Office Action Summary	Application No. 10/583,667	Applicant(s) FALK, CURT GUNNAR
	Examiner JIANYING ATKISSON	Art Unit 3742

DETAILED ACTION

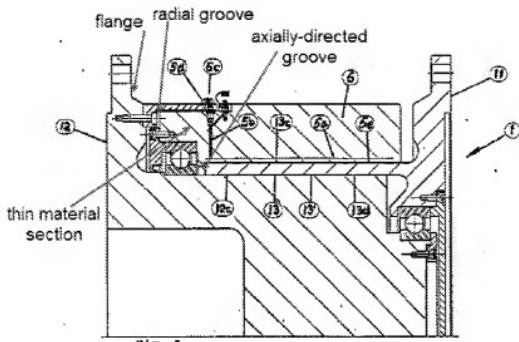
Regarding claim 1, AAPA teaches a safety coupling apparatus (Fig. 1, 1) comprising

a first coupling part (11) for torque and rotary movement with a first shaft or axle (shaft 1'),

a second coupling part (12) for torque and rotary movement with a second shaft or axle (3), and

a safety unit (13) between said first and second coupling parts and which has two settings, a first setting in which torque and rotary movement is transferred between said first and second coupling parts and a second setting in which no torque and rotary movement is transferred between said first and second coupling parts (par. 0091), said safety unit including an expandable subpart (13') that causes said safety unit to be in said first setting when expanded by applying pressure to a cavity (5a) within the safety unit and enclosing said pressure in said cavity, and be in said second setting when said

pressure is evacuated from said cavity (par. 0092), wherein one of said first coupling part and said second coupling part is formed with a generally axially-directed groove (the groove of 12 to hold 13, as annotated below) which surrounds a pressure expandable subpart in said first coupling part and essentially the whole of said cavity, and wherein said expandable subpart, when in its first setting, functions to allow torque to be transferred directly to said first coupling part or said second coupling part via two mutually opposing surface parts (13c, 5e, par. 0092) which are frictionally active against opposing outer parts of the axially-directed groove, wherein said first coupling part includes two axially-directed projections each adapted for coaction with said groove in the second coupling part, and are shorter than said cavity, wherein the expandable part is formed as an end locking means, wherein said second coupling part includes a collar (5) which is essentially centered with respect to said axially-directed groove, said collar is integrated with said second coupling part, and an outer radial groove formed between a flange and said collar, said flange belonging to said second coupling part (as shown below).
